ADDENDUM NO. 1

Venetia Valley TK-8 School Landscape Renovations

Project Number #25-03

Addendum #1

A CONCRETE PAVING SCALE: NTS

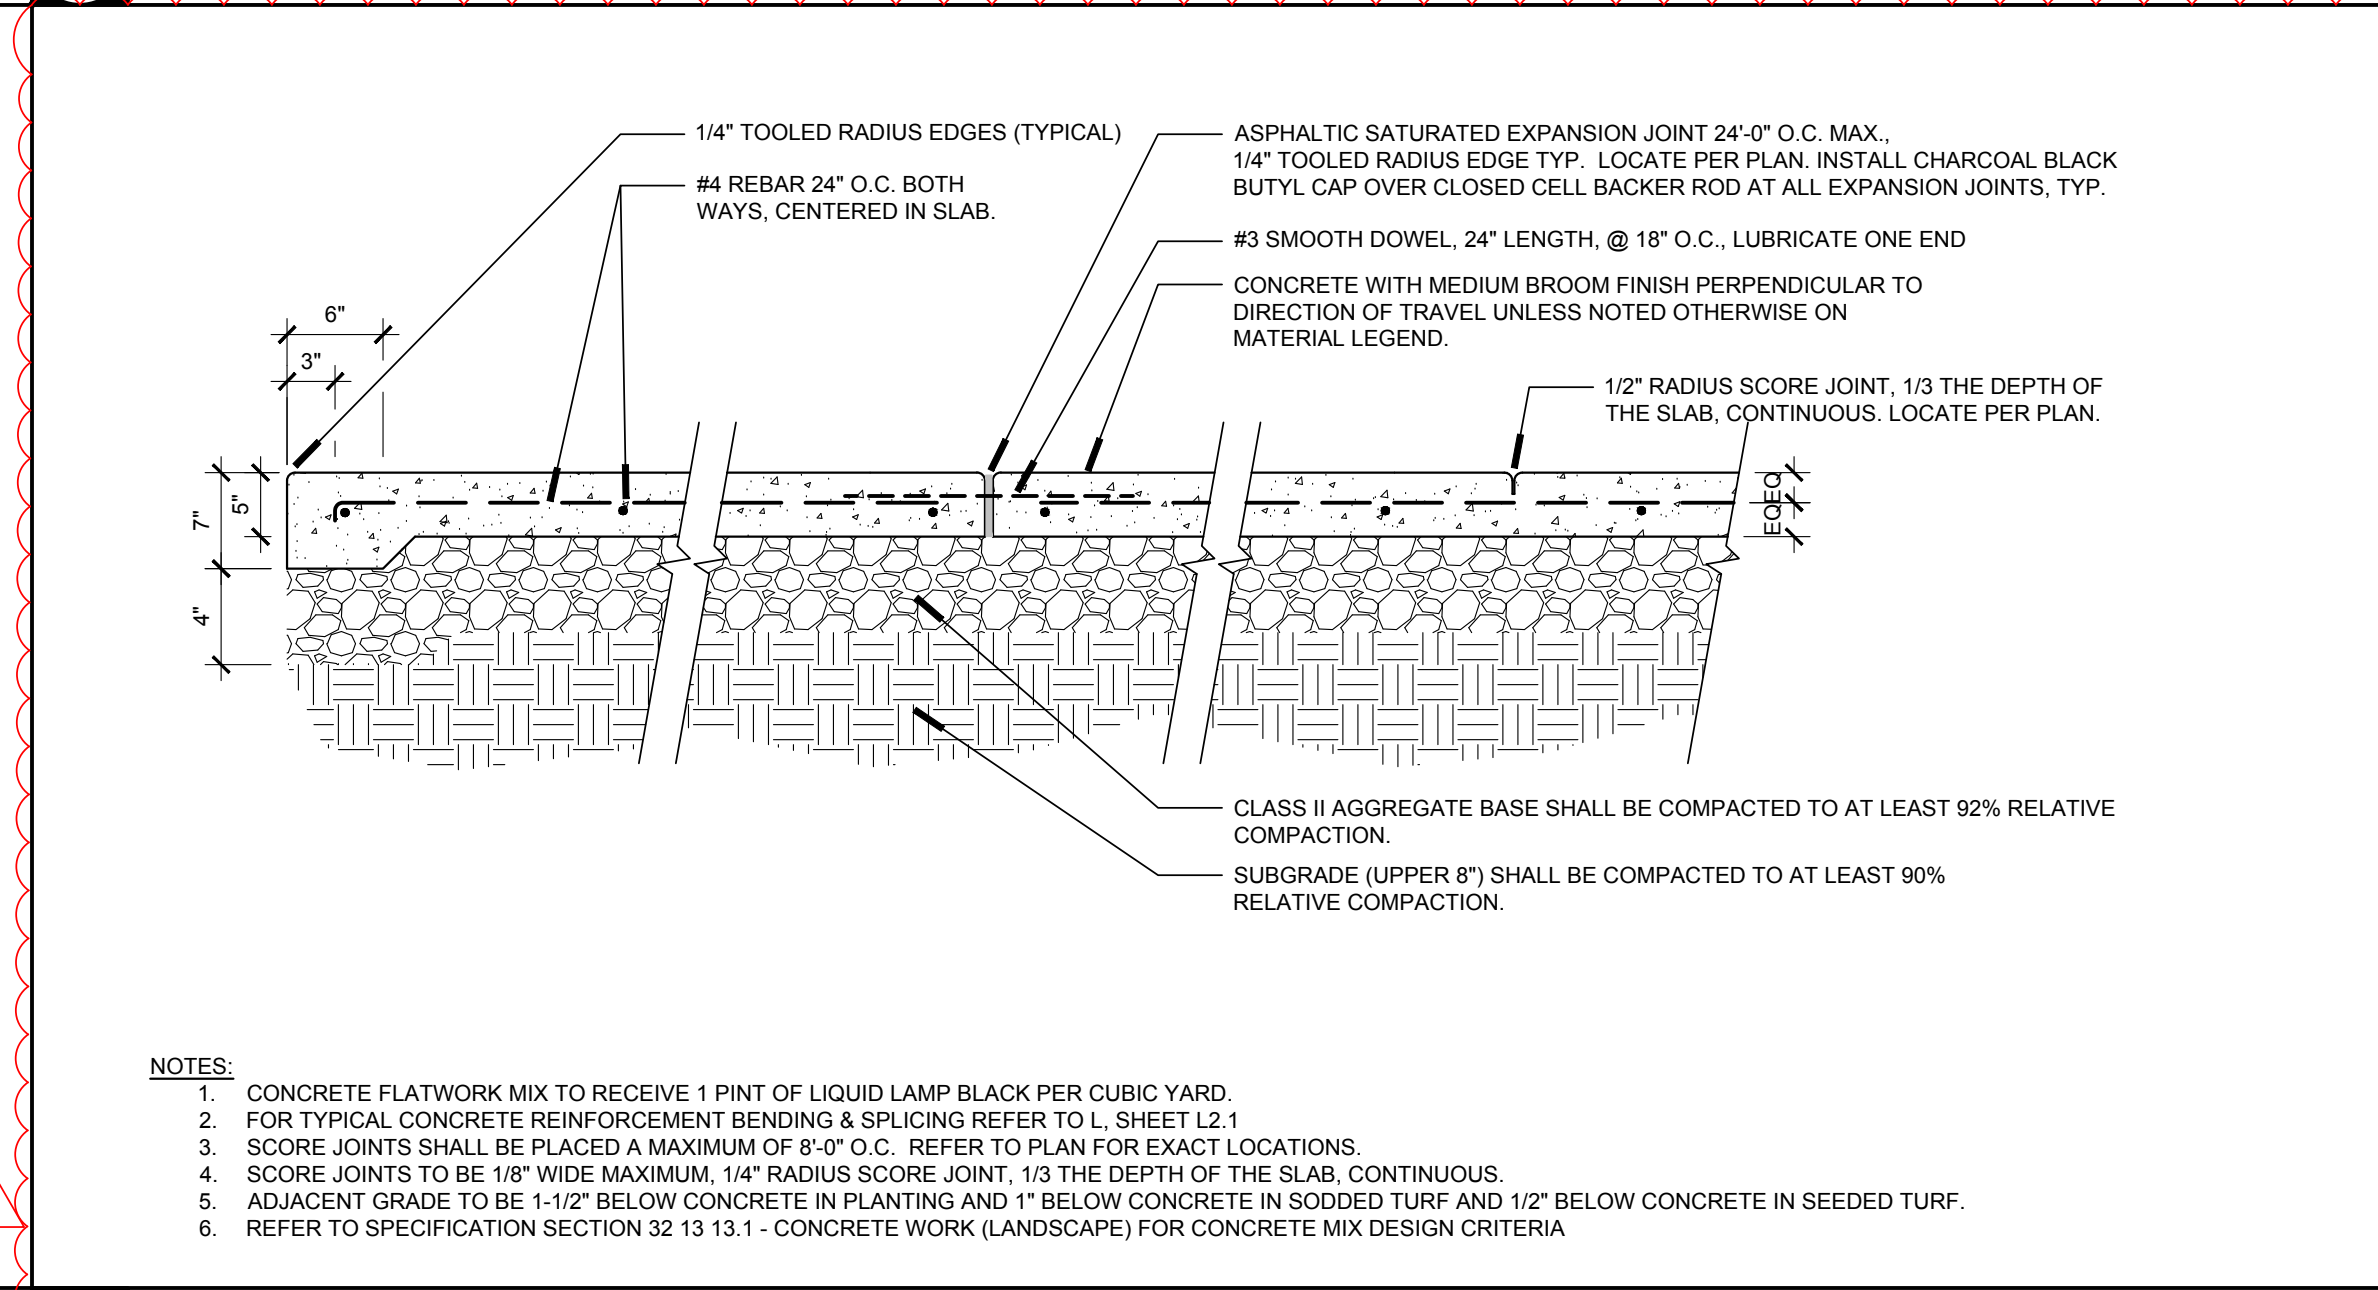
Add: Detail A "Concrete Paving" detail in its entirety.

SHEET NUMBER
ADDENDUM 1
L3.2

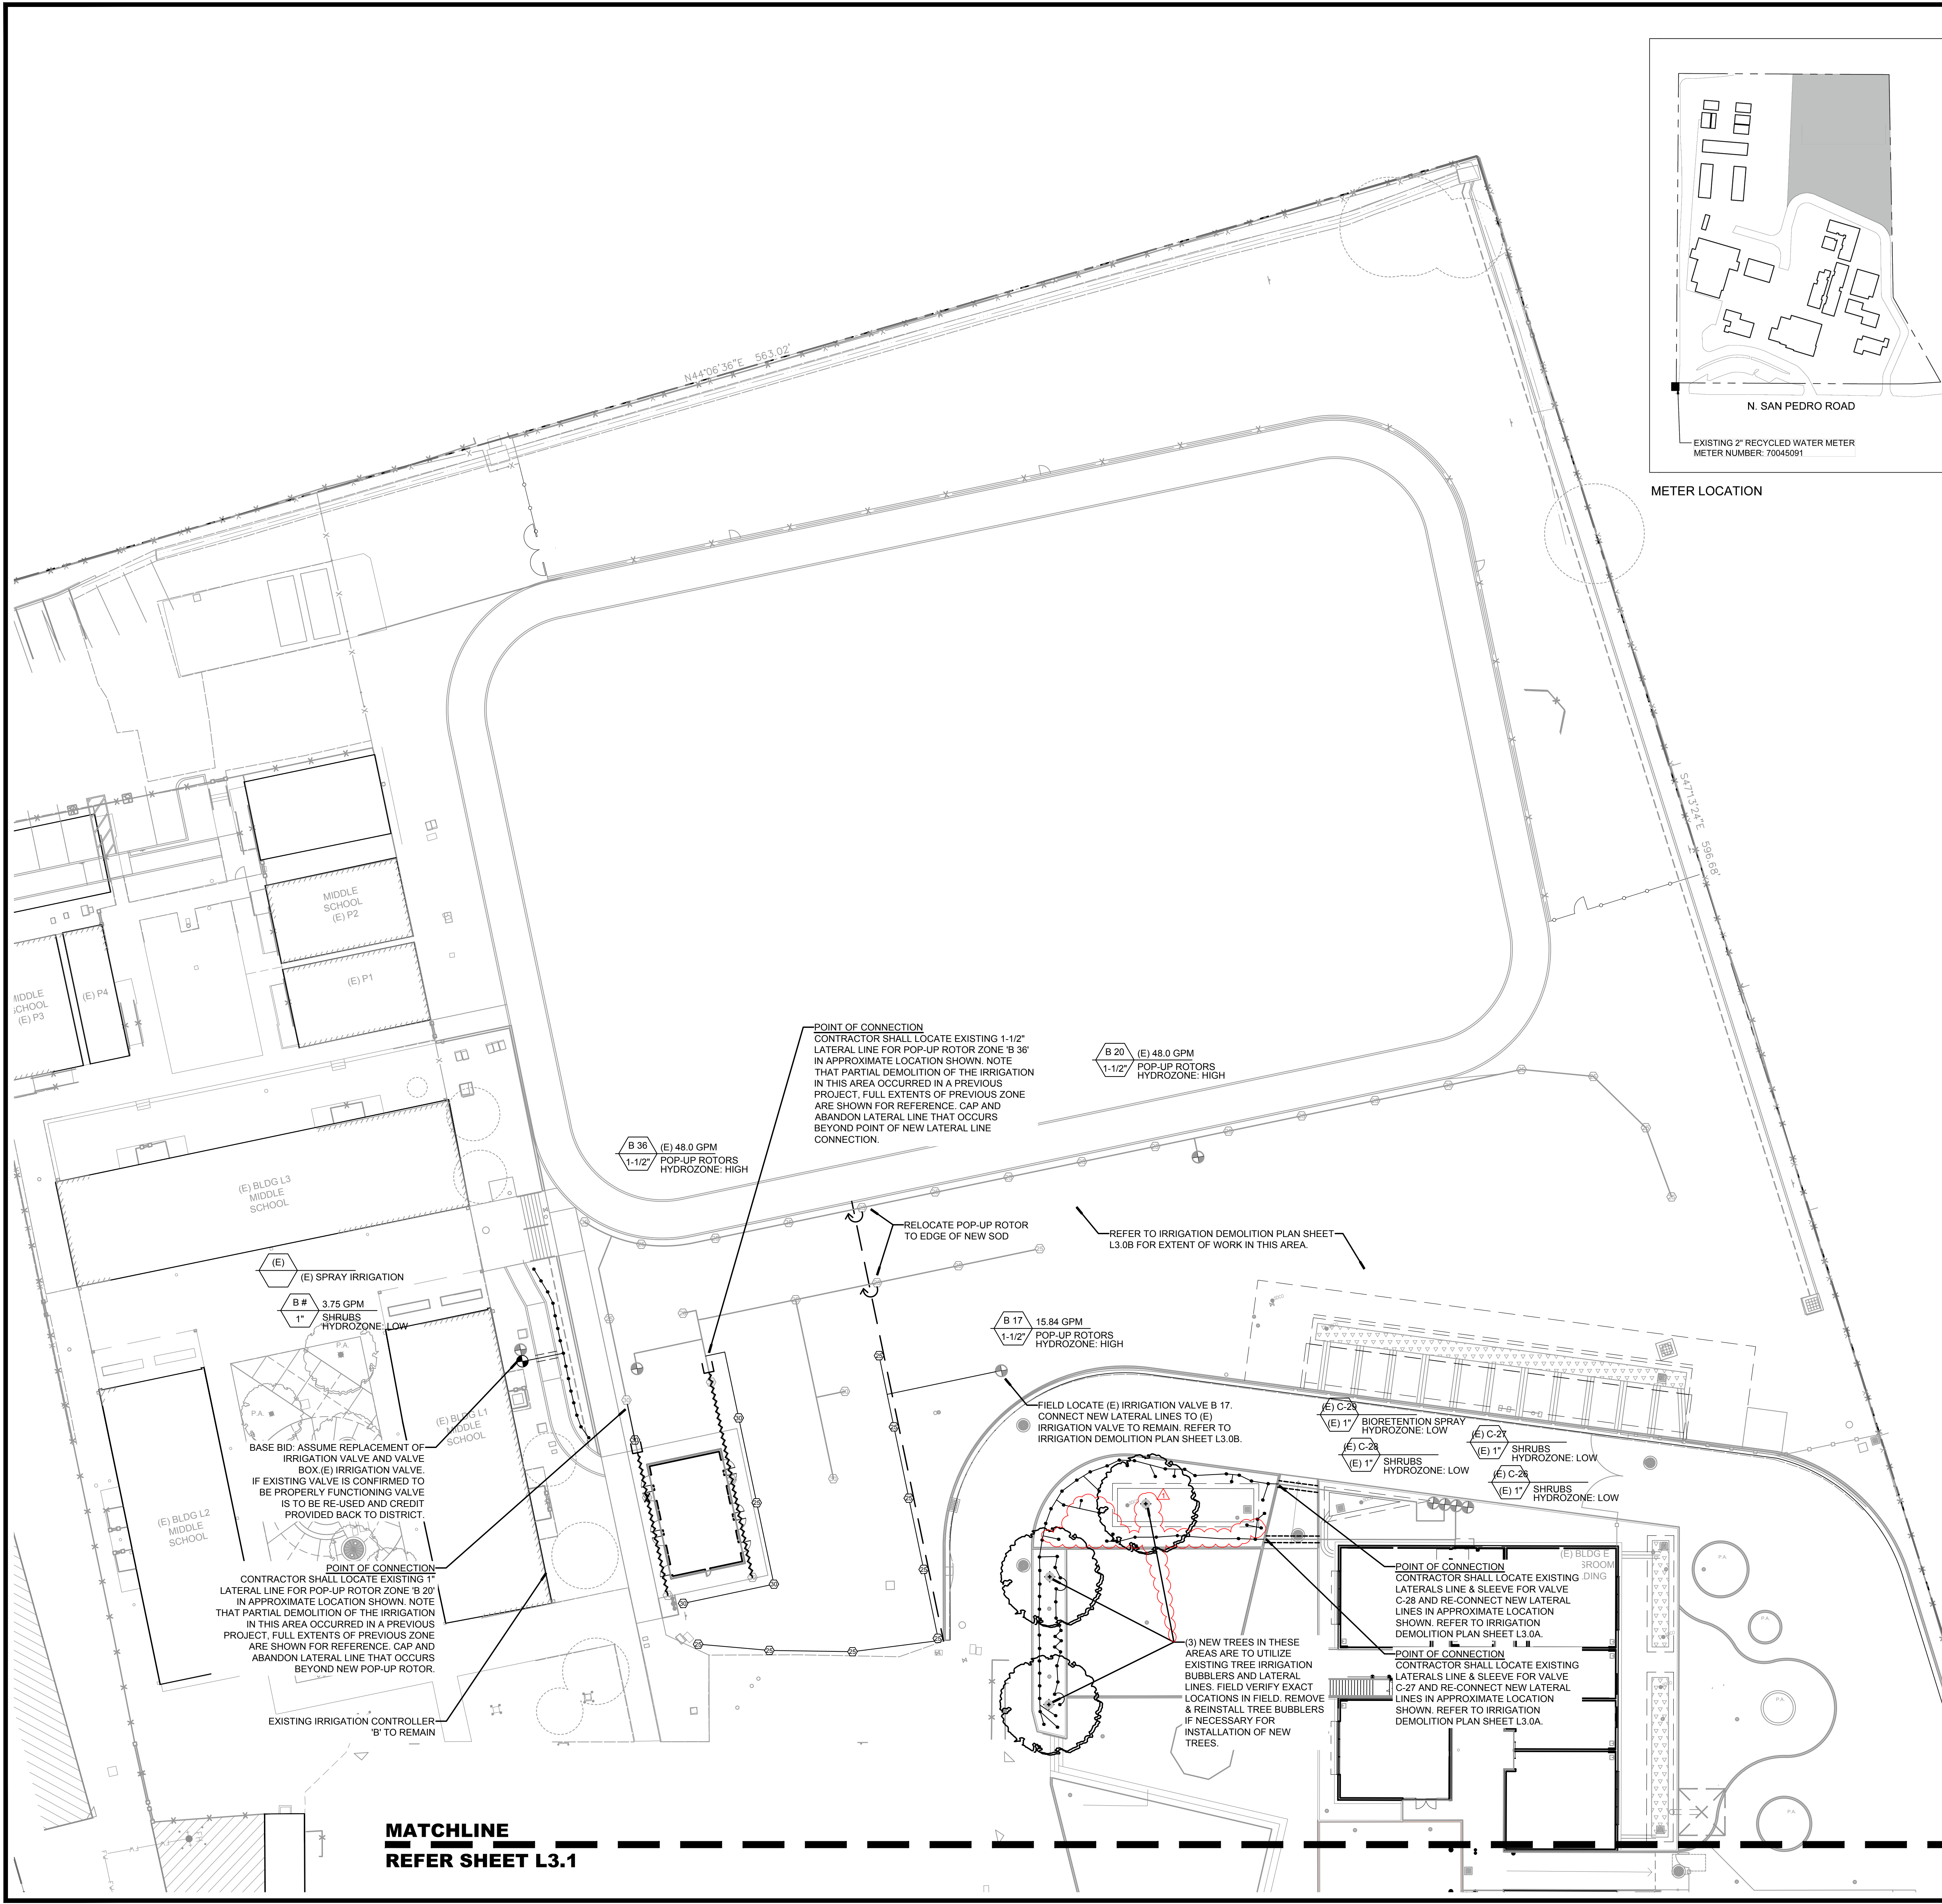
ITEM NO. 1.4: SHEET L3.2 IRRIGATION PLAN:

Revise: Location of (1) Tree.

Revise: Locations of shrub bubblers and associated irrigation lateral lines as clouded. Quantity of shrub bubblers is unchanged.

L5.2

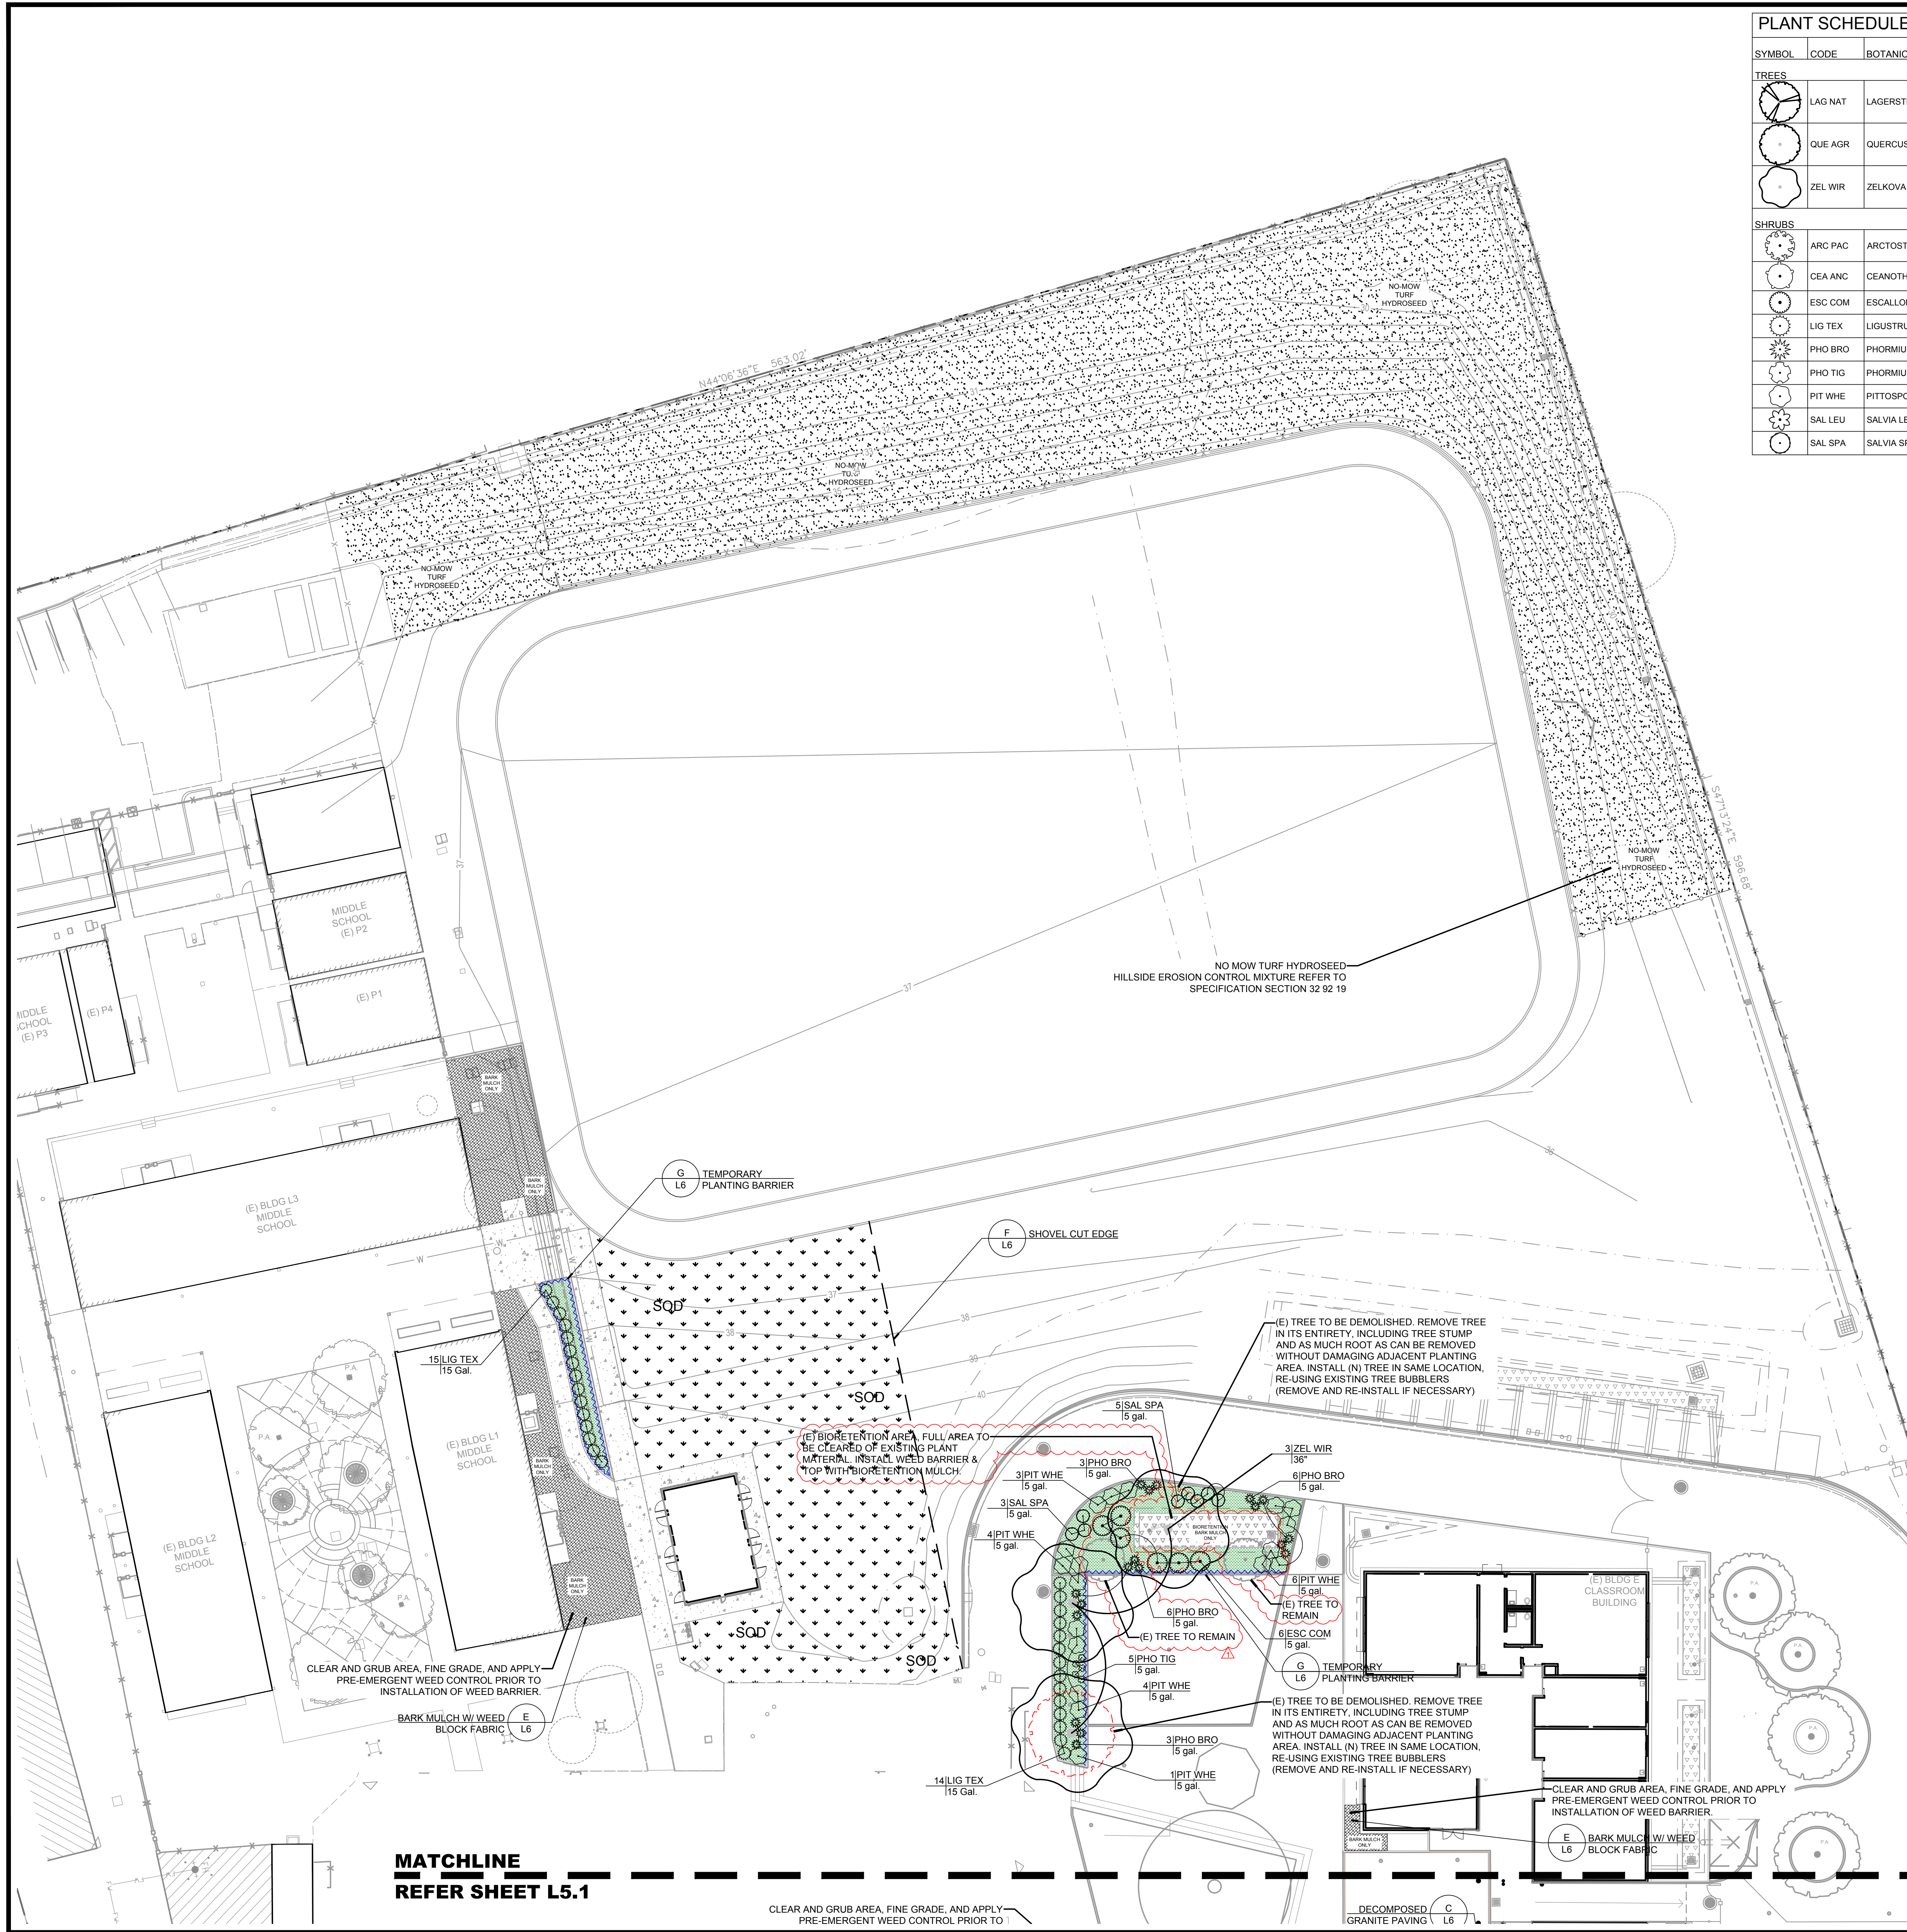
ITEM NO. 1.5: SHEET L5.2 PLANTING PLAN:

Add: (2) existing trees to remain.

Revise: Location of (1) Tree.

Revise: Locations of shrubs adjacent to existing trees to remain. Quantity of shrubs is unchanged.

Omit: Omit the demolition of (1) tree that was determined to have been removed prior to the beginning of the project.
